STATE OF MAINE
DEPARTMENT OF TRANSPORTATION
16 STATE HOUSE STATION
AUGUSTA, MAINE 04333-0016

October 2, 2019
Subject: Ohio Street Bridge Replacement
State WIN: 018722.00
Location: **Bangor**
Amendment No. 1

Bridge Drain-Offset Scupper

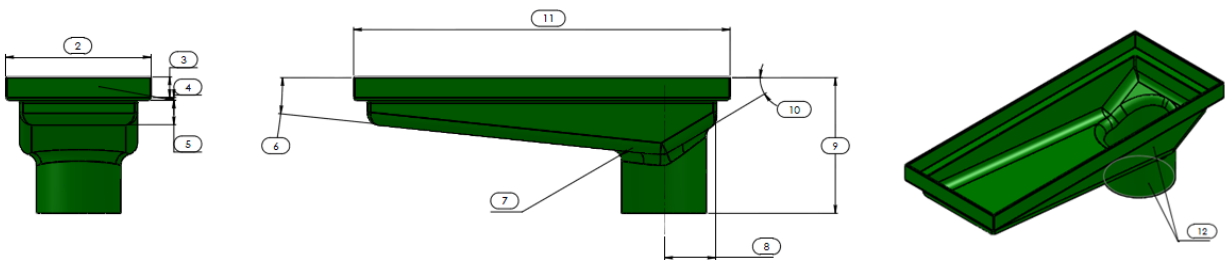
On SHEET NUMBER 16 OF 73, TYPICAL SECTIONS (1 OF 2), in the Proposed Bridge Section, **REMOVE** the callout “Standard Bridge Drain, Type A1 (Typ.)”, and **REPLACE** with “FRP Bridge Drain, Type F (Typ.)”. Make this change in pen and ink.

The bridge shall use a size F offset FRP composite scupper (36 inch long x 12 inch wide x 10 diameter downspout) See Appendix B for additional details. The bottom of the downspout shall extend a minimum of 12 inches below the bottom of the beams. For bridge decks with integral concrete wearing surface, the drain pan depth shall be reduced to provide adequate concrete cover.
